**APPLICATION FOR PERMISSION
UNDER SECTION 16 OF
THE TOWN PLANNING ORDINANCE
(CAP. 131)**

For Official Use Only 請勿填寫此欄	Application No. 申請編號	A17C-PH/1042
	Date Received 收到日期	2024-12-17

有關 A/YL-PH/1042 規劃申請補充資料

Government Departments' General Comments

場地設計圖則：

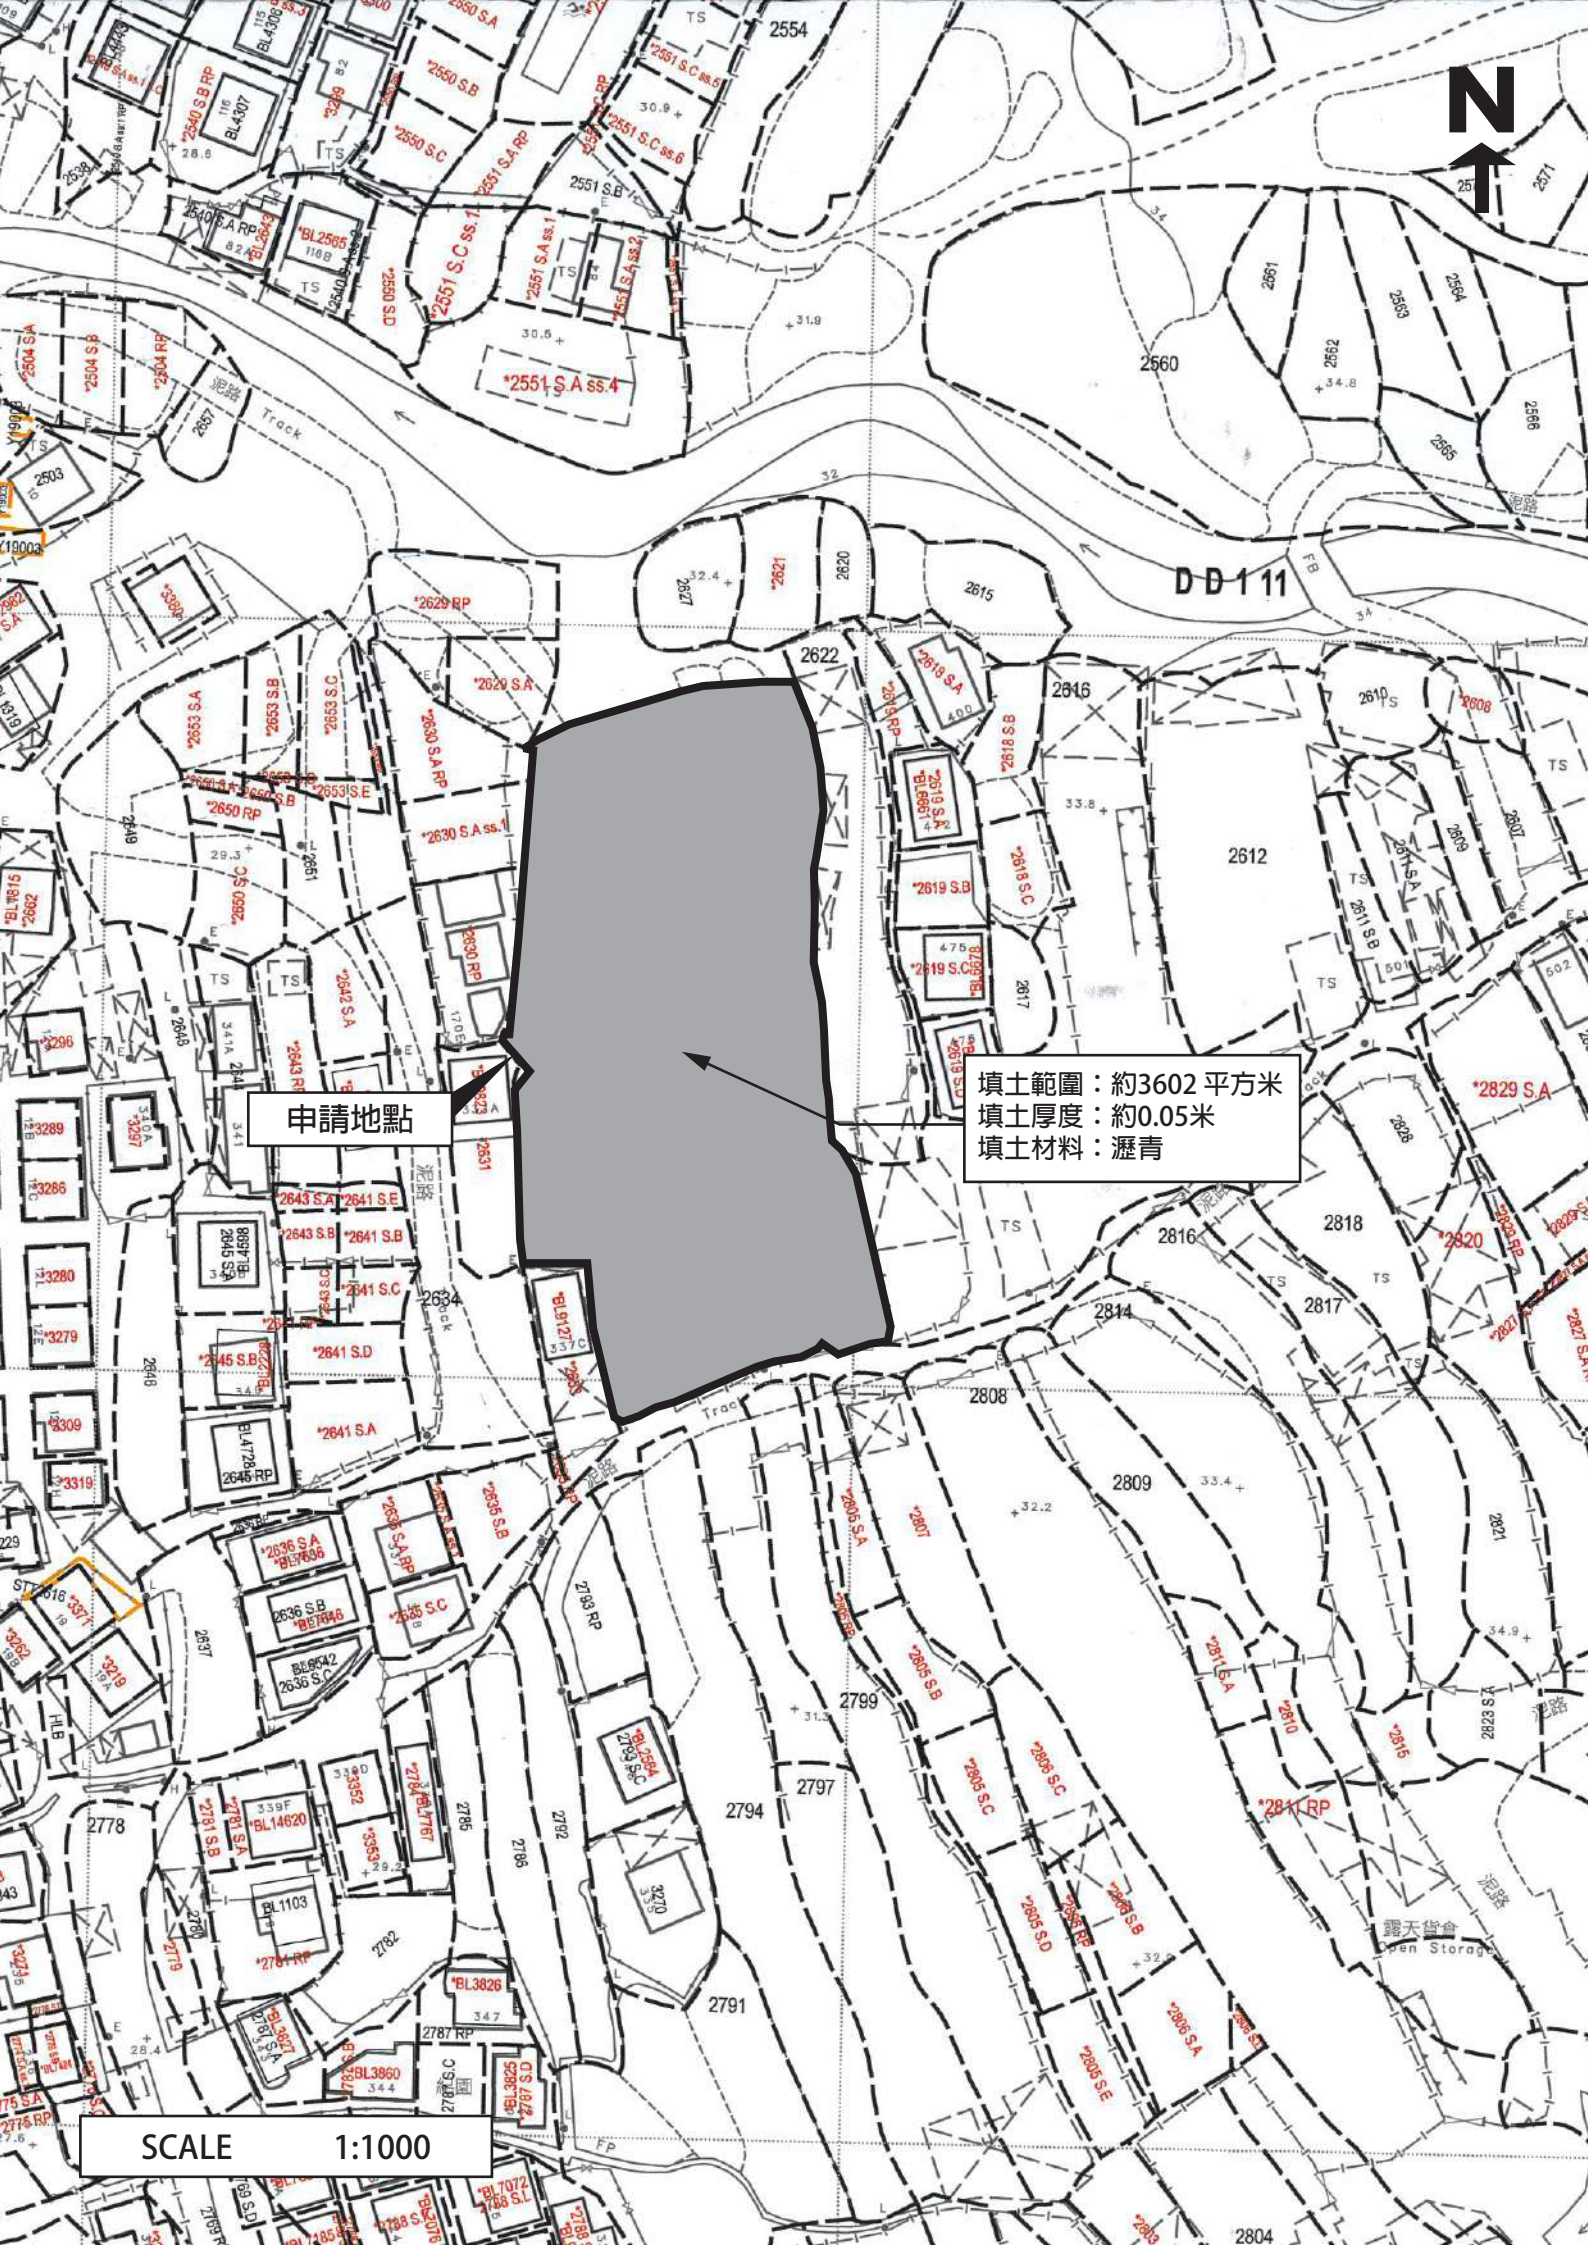
The extended operation entails the filling with concrete of a substantially larger tract and with it the possible impact on the natural drainage capacity.

1. 申請地點的部份填土工作已在規劃許可 A/YL-PH/994 時期完成，填土厚度約 0.05 米，場地內的香港主水平基準由+32.45mPD 增加至現時的+32.50mPD，填土材料為瀝青。本次規劃申請中新增的土地面積約 791 平方米，作臨時商店及服務行業(汽車陳列室)用途，場地內不涉及挖土，本次申請中提及的填土是為了規範化相關的填土事宜。

渠務排水圖則：

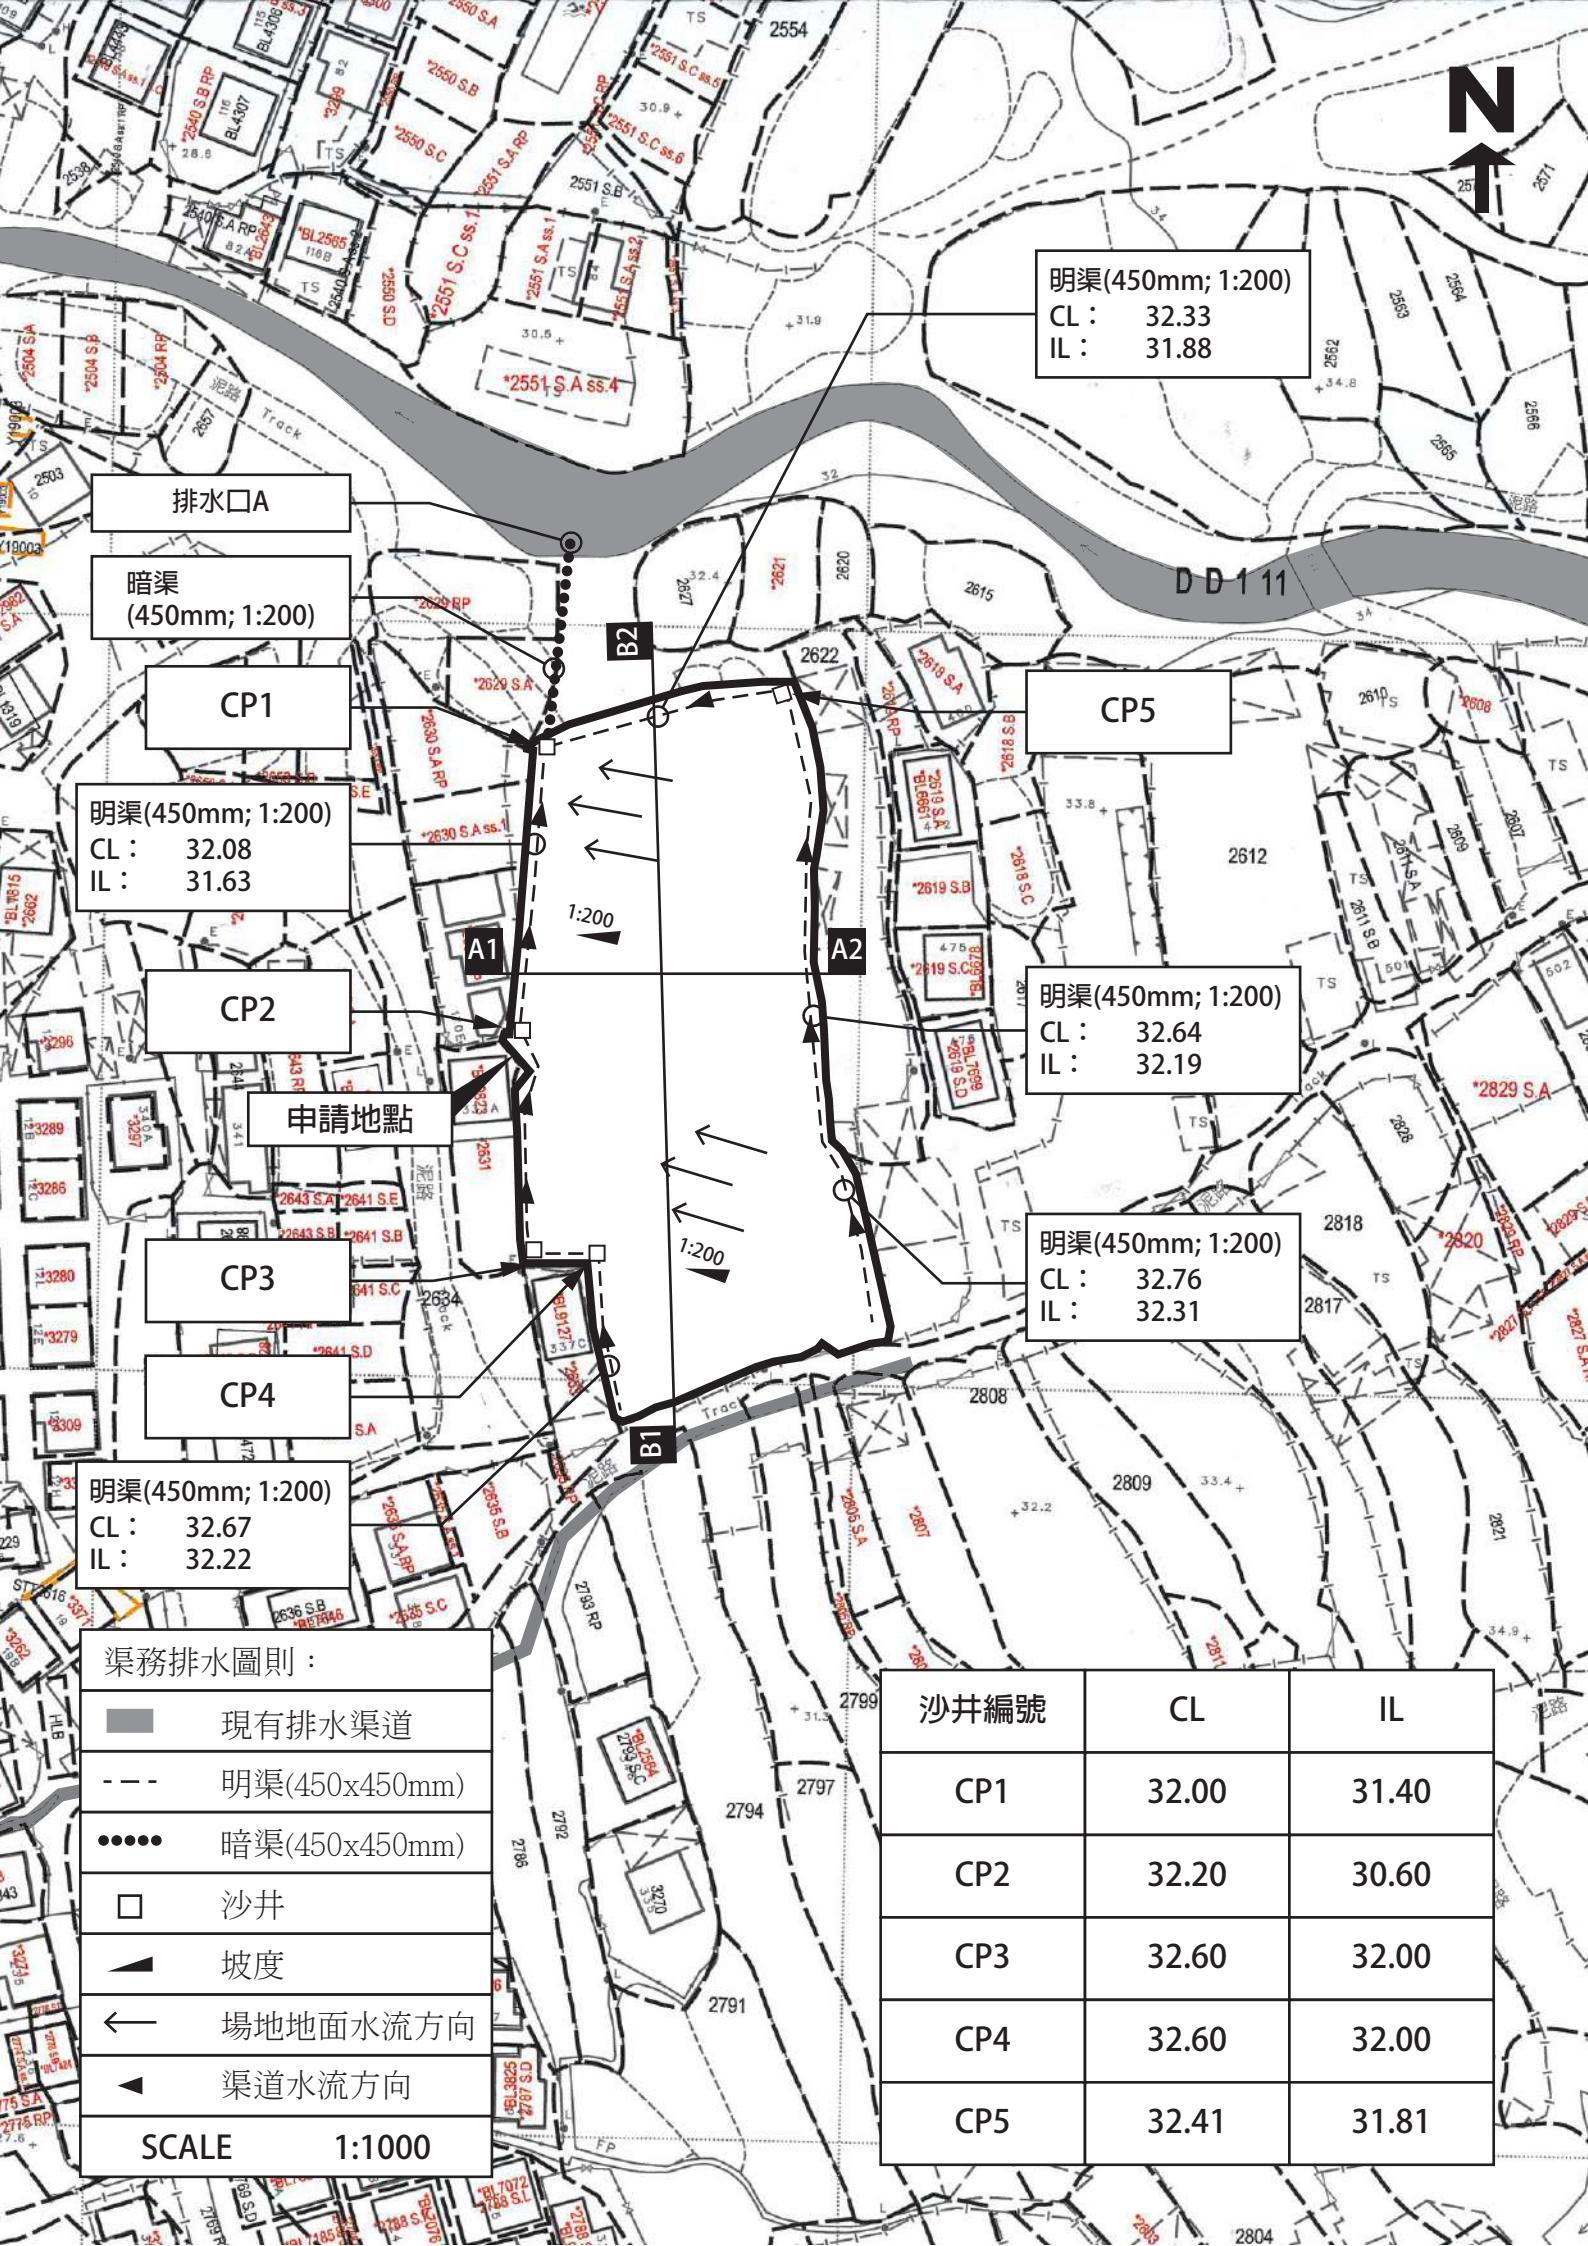
- (iv) meet the statutory requirements under relevant environmental legislation;
- (e) to note the comments of the Director of Drainage Services that:
 - (i) peripheral surface channels shall be provided along the site boundary to collect the surface runoff accrued on the application site and to intercept the overland flow from the adjacent lands. U-channel at the southern side of the site shall also be provided;

- (ii) calculations shall be submitted to demonstrate the proposed drainage 450 x 450 underground pipe is adequate to discharge the surface runoff accrued on the

application site and the overland flow intercepted from the adjacent lands to the proposed discharge point; and

- (iii) for the cross section details at discharge point A, the I.L. of discharge pipe shall be indicated.
- (f) to note the comments of the Director of Fire Services (D of FS) that:

消防裝置圖則：

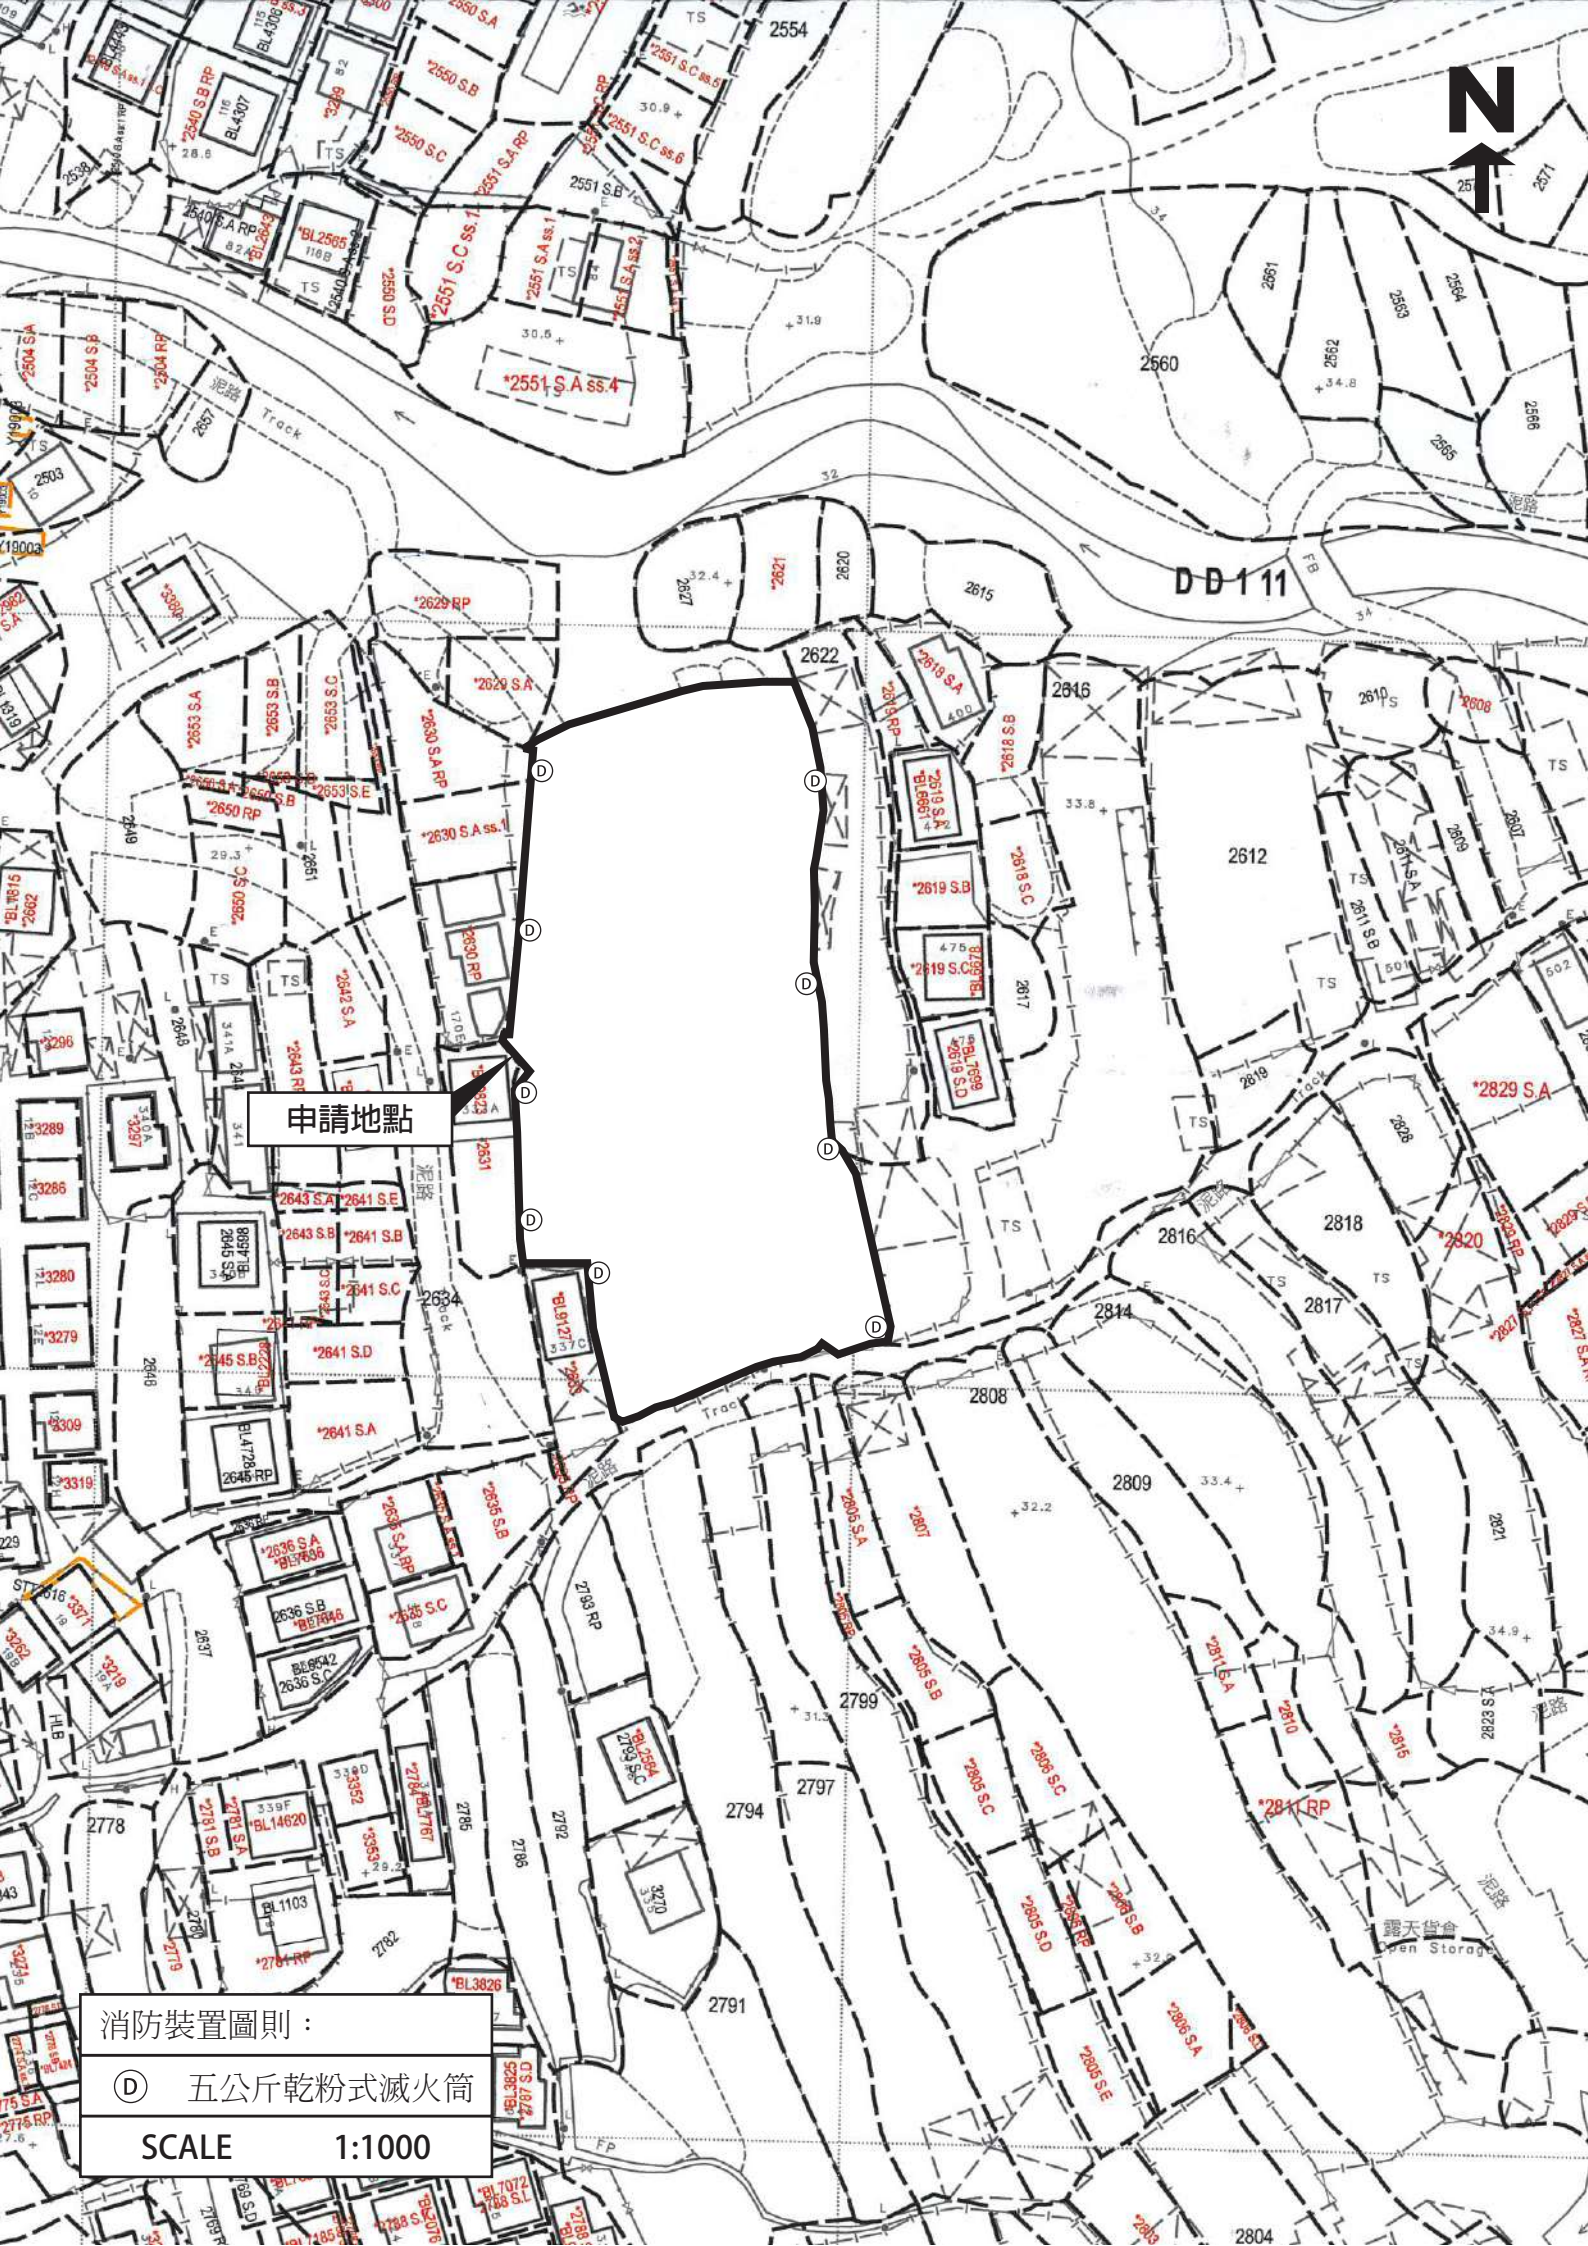
- (i) in consideration of the design/nature of the proposal, fire service installations (FSIs) proposal is required. The applicant is advised to submit relevant layout plans incorporated with the proposed fire services installation (FSIs) to the Fire Services Department (FSD) for approval;

- (ii) the layout plans should be drawn to scale and depicted with dimensions and nature of occupancy, and the location of proposed FSIs to be installed should be clearly marked on the layout plans; and
